28 February 2021

Beaches Link Project EIS Submission 28 February 2021

Traffic signals at intersection of Wakehurst Parkway and Warringah Road unfairly and unnecessarily discriminate against active transport users.

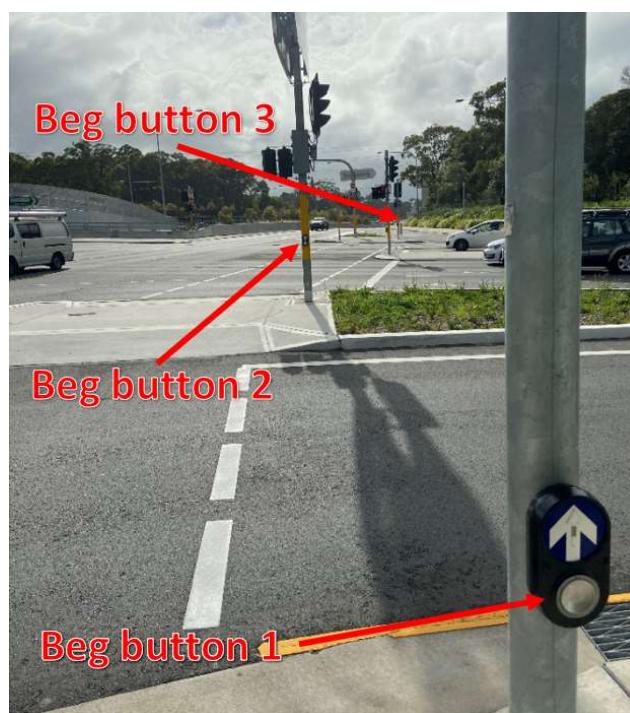
The photograph below shows the crossing on the southern side of Warringah Road across Wakehurst Parkway. The crossing is broken up into 3 segments. Those wishing to continue along Warringah Road must press each button when they reach it in order to request permission to cross the next segment.

Depending on the time of day and the point at which the user arrives in the lights cycle, it can take up to five minutes or more to negotiate a legal crossing at this intersection. Most users ignore the lights for part or all of the cycle, and use their own judgement to cross. This is easily addressed by a coding change.

The sections of crossing controlled by buttons 1 and 2 in the image below should automatically default to a green pedestrian and cyclist crossing light while through traffic on Warringah Road has a green traffic light, and should not require users to press the beg button to qualify for a green signal. The end of the red flashing crossing light sequence should coincide with the start of the amber light traffic light for parallel traffic.

The slip lane providing a left turn from Warringah Road to head south along Wakehurst Parkway should also have the beg button removed and the signal default to green while the lights controlling traffic heading south are green.

This treatment should be adopted on all sides of the intersection. Automatic green lights for active transport users are in use in the Sydney CBD and works well. I note its recent implementation at Hilmer St.

Corner treatments with traffic lights are poor and set up conflict between pedestrian and bicycle users.

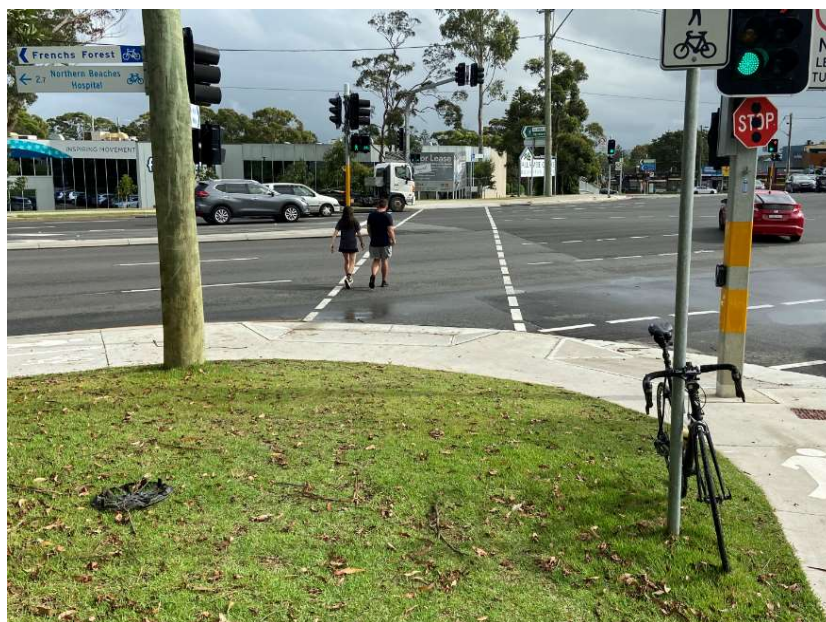
Typically, traffic light corner treatments around the Northern Beaches Hospital Precinct consist of an unbroken centre line on the approach to the corner apex and a traffic signal pole (sometimes two) on the alignment with this unbroken centre line.

For bicycle riders turning right at these corners, they provide very tight dimensions and an uneven, off-camber surface to negotiate, creating a high risk of a collision between the bicycle's handlebars and the pole, or a fall as the bicycle has its momentum interrupted by the uneven surface due to the slow speed required to avoid leaning too far into the corner.

Where the rider is on a mountain bike, the handlebar dimensions of which routinely reach or exceed 800mm on current bike designs, a clash with the pole becomes a near certainty.

The result is that riders ignore the unbroken centre line and cut the apex. The corner treatment should not encourage riders to disregard path markings in order to prioritise their safety.

Where pedestrians are waiting to cross, the lack of space brings riders and pedestrians into conflict.

The situation is readily resolved by redirecting the cycleway closer

to the corner's centre point. This would eliminate the risks to riders and provide pedestrians and riders waiting to cross with safe staging space to adjacent to the traffic signals. Cost to mitigate is in the region of \$5,000 per intersection corner.

Poor sign placement creates a collision risk after dark

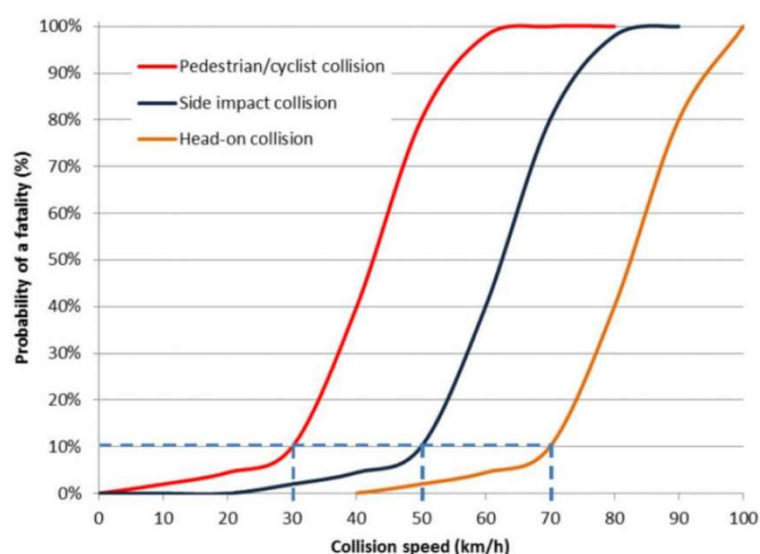
Numerous instances of placing sign and traffic signal posts in the centre of the contra-flow side of the cycle path communicate a poor regard for cyclist safety.

While these are visible and avoidable during daylight hours, I draw to your attention the fact that bicycle lights are not required to meet forward night vision requirements for riders, they are only required for the purpose of being visible to other vehicle operators for a distance of 200m under [NSW Road Rule 259](#). While some riders do have high quality forward vision lights, they are typically quite expensive and their price confines their use to the small minority of riders using high-value bikes.

The placement of these signs fails to consider risks of collision with path furniture at night or in conditions of poor visibility such as wet weather.

It is essential these mistakes are corrected along Warringah Road and are not repeated on Wakehurst Parkway when the cycleway is built.
